Office Action Summary	Application No. 10/822,572	Applicant(s) LLOYD ET AL. 	
	Examiner James R. Harvey	Art Unit 2833

DETAILED ACTION

** Claim(s) 1, 3-11 and 13-19 are rejected under 35 U.S.C. 103(a) as being unpatentable over Hornchek et al. (US 6541991) in view of Higashi (US Pub. 2004/0166702).

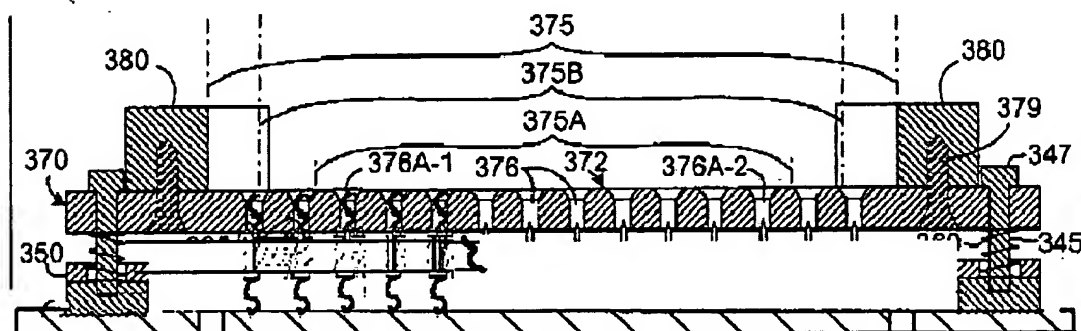
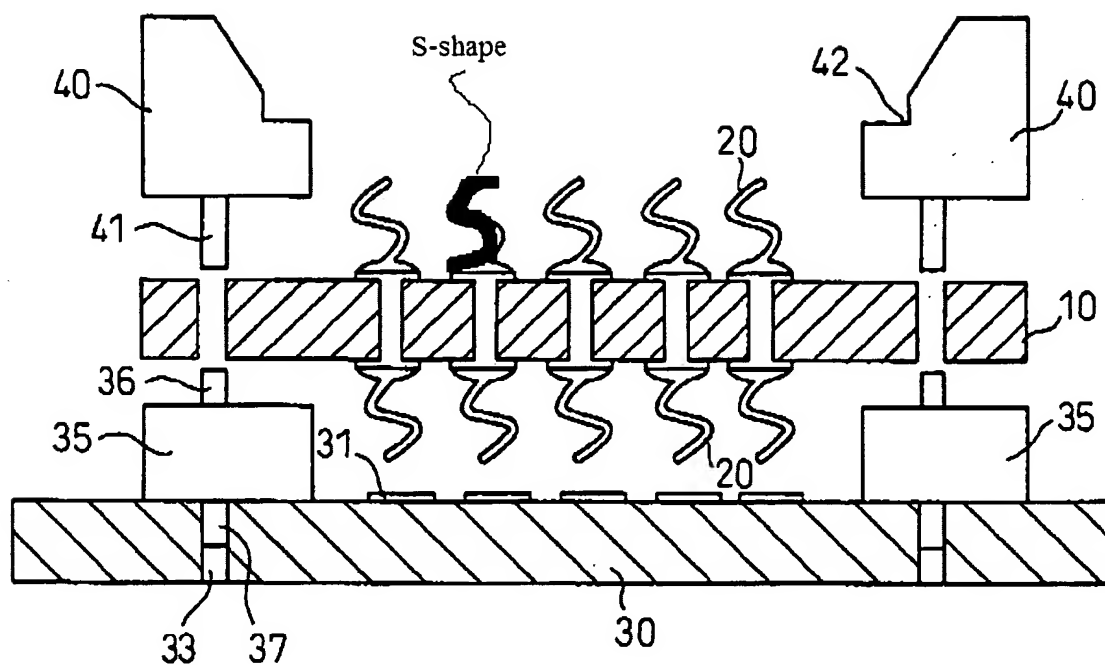
Higashi shows spring contacts 20 (see examiner's figure) are S-shaped and the combination of Hornchek and Higashi is considered to be adapted to make wiping electrical contact with a solder ball inserted into the aperture (see examiner's figure).

Further, it would have been obvious to one of ordinary skill in the art at the time the invention was made to replace the mounting plate 350 with spring contacts 320 of Hornchek with the mounting plate 10 with the S-shaped spring contact 20 Higashi (see examiner's figure).

Higashi shows spring contacts 20 (see examiner's figure) are S-shaped and the combination of Hornchek and Higashi is considered to be adapted to make wiping electrical contact with a solder ball inserted into the aperture (see examiner's figure).

Further, it would have been obvious to one of ordinary skill in the art at the time the invention was made to replace the mounting plate 350 with spring contacts 320 of Hornchek with the mounting plate 10 with the S-shaped spring contact 20 Higashi (see examiner's figure).
